Windsor-Toronto-Montreal (WTM) Airspace and Services Review

Toronto Terminal Control Area (TCA) Changes

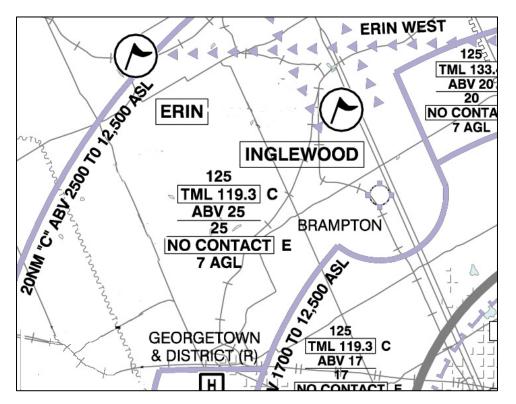
The Toronto Class C terminal airspace floors will be raised 1 foot, e.g. "ABV 1700" to provide VFR aircraft with additional altitude options. VFR aircraft will be able to fly beneath the Class C airspace at 1700 'ASL, 2000'ASL, 2500'ASL or 3500'ASL, without a clearance from ATC.

The 2,500' ASL Class C "cut-out" around Brampton (CNC3) has been extended to the east, parallel to Hwy 10, and to the railroad tracks in Georgetown to the southwest.

These changes will take effect March 12, 2009 at 09:01 Coordinated Time Universal Time (UTC). The appropriate aeronautical publications will be amended.
